INTERNAL MEMORANDUM

SUBJECT: P/22/0083 | Proposed barn conversion to form a residential dwelling | Tyla-Glas Farm Craig Y Hendre Bedlinog Treharris CF46 6SN

1. Tyla-Glas Farm, Bedlinog, Merthyr Tydfil. Bat Survey, Issue 1, **Version B**. October 2022. Be Ecological Ltd [***dated 01/11/22***]

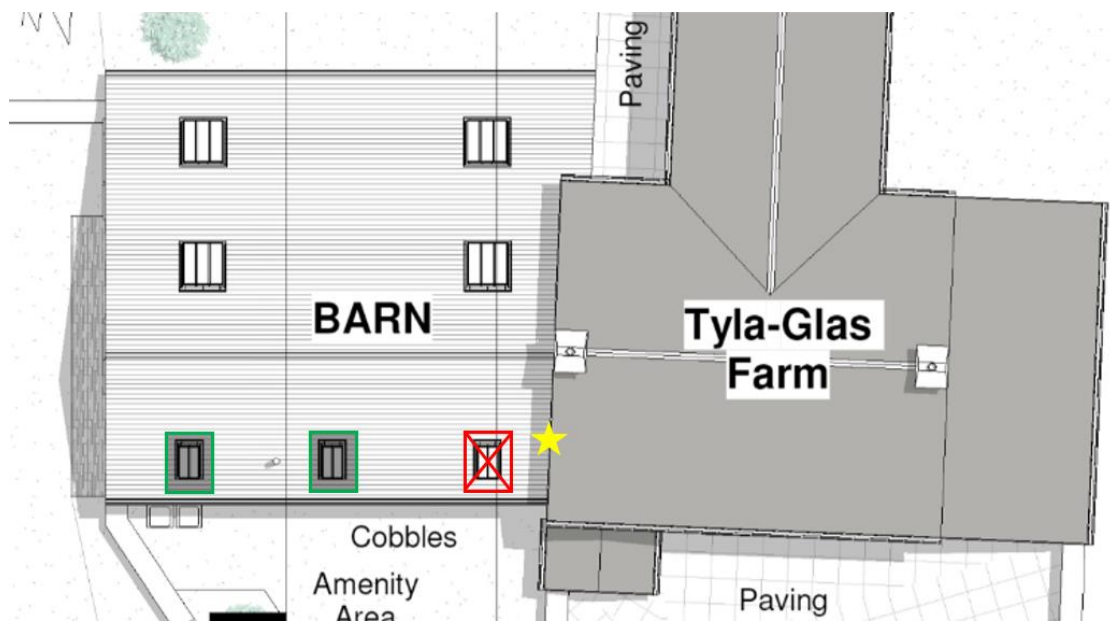
- o A change in design regarding the roof lights is required. Document 1 suggests relocation of the roof lights on the south eastern elevation or the addition of

electric blinds that close at dusk. Electric blinds with no other mitigation will not be acceptable as these can fail or can be overridden. The common pipistrelle roost entrance on the south western gable end of the farmhouse is shown on the drawing below (yellow star). The best solution therefore, would be to remove the roof light on the south eastern pitch closest to the roost entrance (crossed in red). Low transmission glazing treatments will then be used for the remaining roof lights on the south eastern pitch (green boxes). NB light transmission through 'tinted' glass can be reduced with specially coated materials, similar to blackout glass or tinted windows, which can reduce visible light transmittance.
